UNITED STATES
ATOMIC ENERGY COMMISSION
WASHINGTON, D.C. 20545

File (SEFOR, Docket No. 50-231)

SAFETY EVALUATION FOR PROPOSED CHANGE NO. 3 TO THE TECHNICAL SPECIFICATIONS

FIGURE 1. Criteria for Operation and Limits Applicable Now and Applicable under Proposed Change No. 3.

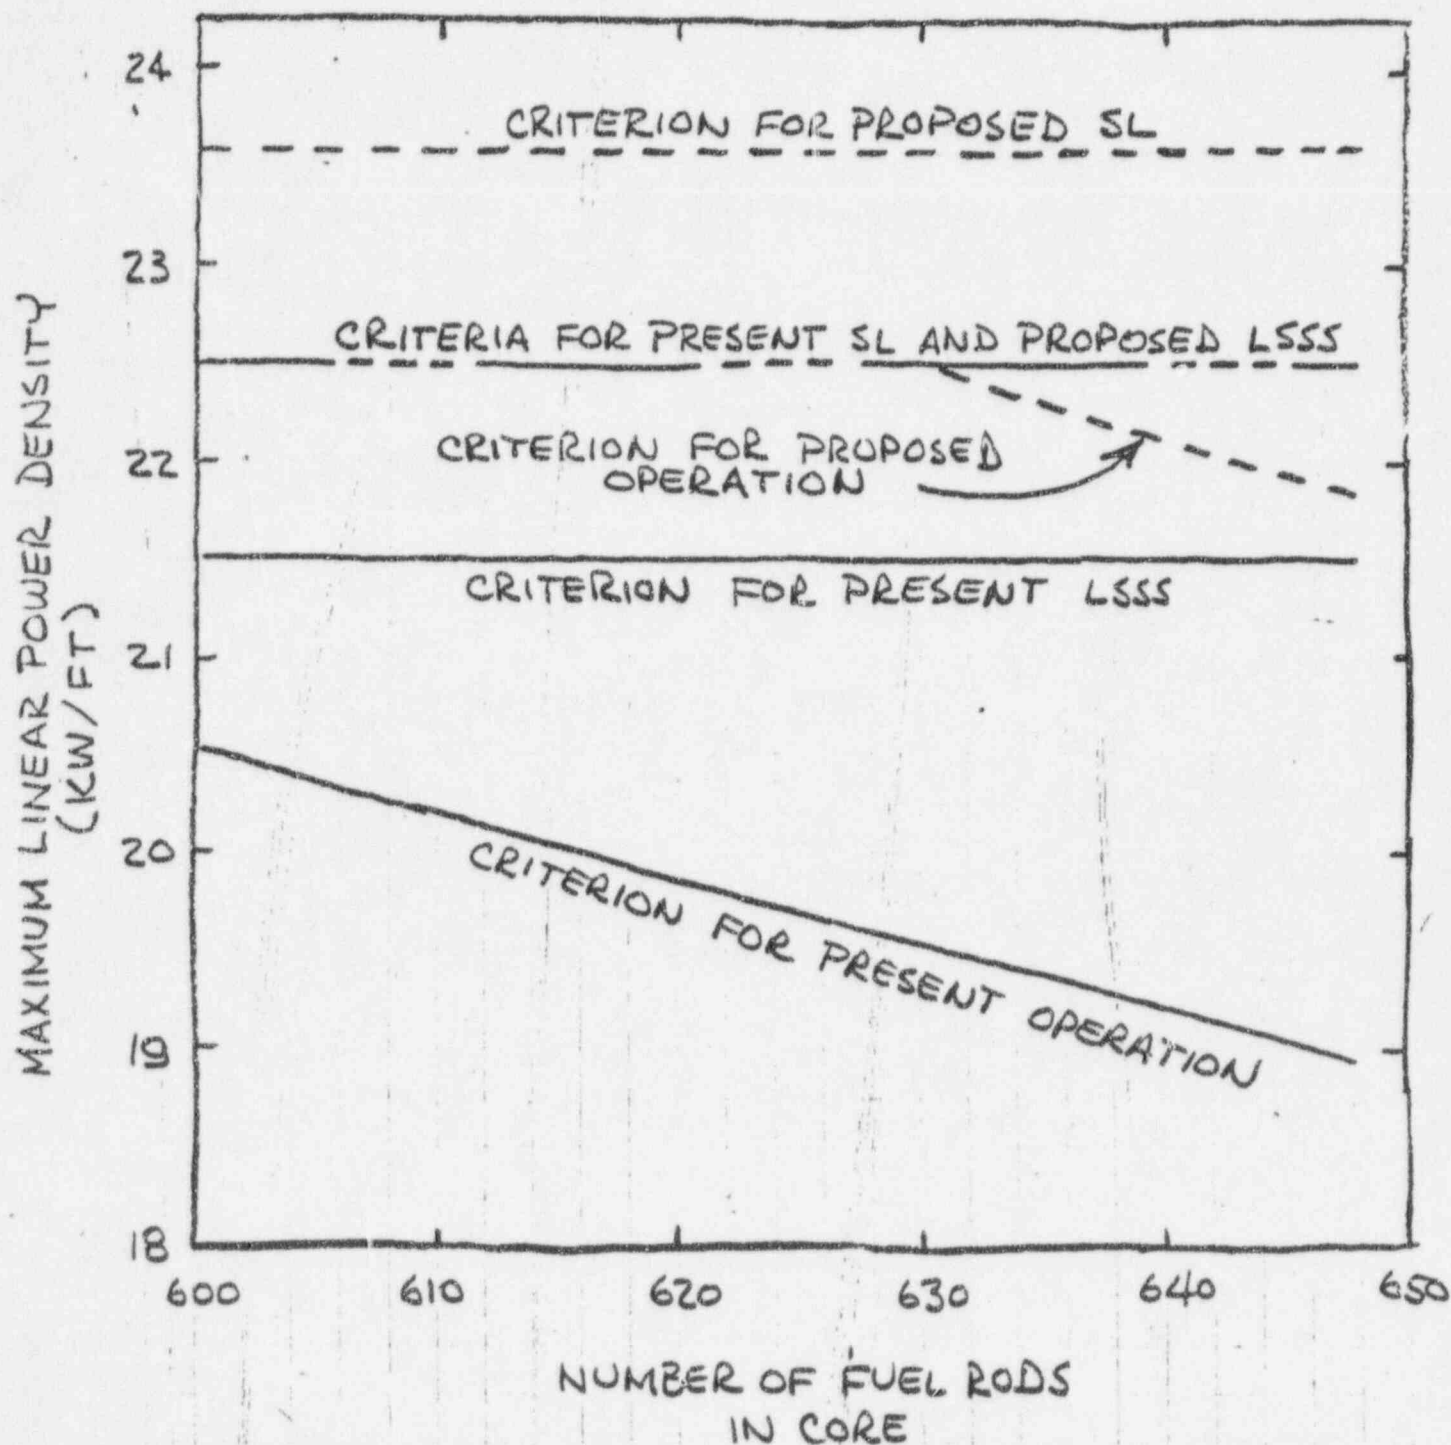
With regard to steady-state operation above 17.5 MWt with the inner guinea pig rods in place, the proposed change to the bases for the SL clearly describes the increase in linear power density (see attached Figure 1 for a comparison of conditions) and the consequent reduction in the "allowance for uncertainty in onset of damage or consequences". To compensate for this reduction, GE proposed additional surveillance of the rods to be performed after reaching 20 MWt, after the first 300 MWt-days above 17.5 MWt, and at every 600 MWt-days thereafter. In our opinion, the proposed additional surveillance is adequate.
